Access Compliance Report

Public Rights-of-Way

(Curb Ramps)

Intersection ID: 47440	Main Street: ACCIPITER_WY	Cross Street: KALISPELL_LN	Location: SW
ADA ID: 25FB974D1B73	Ramp Type: BlendTrans1	Initial Pass/Fail: Fail	Overall Compliance: No
		Severity Score: 8.75

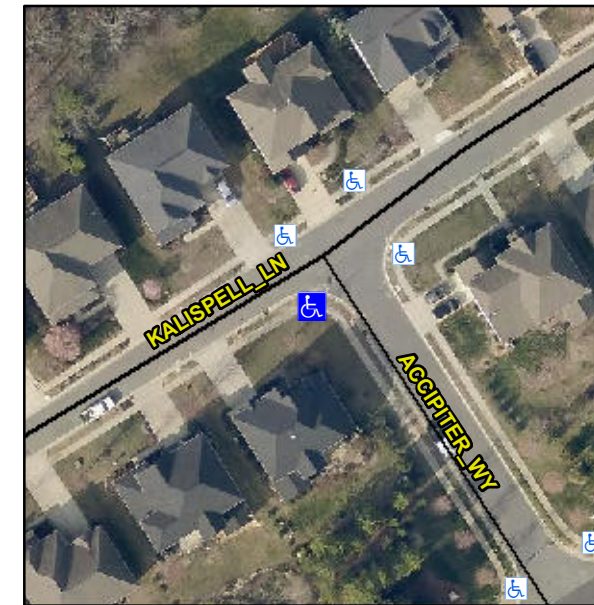
Not Found, R304.5.1

Compliance	Description	Data	Compliance	Description	Data
N/A	Ramp Length (in)	48.0	Yes	BlendTrans Slope (%)	2.5
No	Ramp Width (in)	47.0	Yes	BlendTrans XSlope (%)	0.7
N/A	Flare Type LT	N/A	N/A	Flare Type RT	N/A
N/A	Flare Slope LT (%)	N/A	N/A	Flare Slope RT (%)	N/A
N/A	Flare Traversable LT?	N/A	N/A	Flare Traversable RT?	N/A
N/A	Landing Length (in)	N/A	N/A	DWS Provided?	N/A
N/A	Landing Width (in)	N/A	N/A	DWS Contrast?	N/A
N/A	Landing Slope (%)	N/A	N/A	DWS Length (in)	N/A
N/A	Landing X Slope (%)	N/A	N/A	DWS Full Width?	N/A
N/A	Landing Curb? (Y/N)	N/A	N/A	DWS Offset (in)	N/A
N/A	Shared Landing?	N/A			
N/A	Gutter Ponding?	N/A	N/A	Gutter Slope (%)	N/A
N/A	Gutter Lip Ht (in)	N/A	N/A	Gutter X Slope (%)	N/A
N/A	Painted X Walk1?	No	N/A	Painted X Walk2?	No
	X Walk 1 Direction	To NE		X Walk 2 Direction	To NW
	X Walk 1 Width (in)	N/A		X Walk 2 Width (in)	N/A
	X Walk 1 Slope (%)	1.4		X Walk 2 Slope (%)	1.2
	X Walk 1 X Slope (%)	1.1		X Walk 2 X Slope (%)	3.0

N/A	Ramp inside XWalk1?	N/A	N/A	Ramp inside XWalk2?	N/A
	Road Slope (%)	1.3		Clear Space?	N/A
	Road X Slope (%)	1.9	N/A	Clear Space to XWalk (in)	N/A
N/A	Any Obstructions?	N/A	N/A	Storm Grate/Utility Hazard?	N/A
	Obstruction Type			Storm Grate/Utility Type	
		N/A			N/A
			Yes	Surface Condition? (G/P)	Good
			No	Curb Slope (%)	13.1

Remove & Replace Curb Ramp With Two New Directional Ramps or Equivalent.
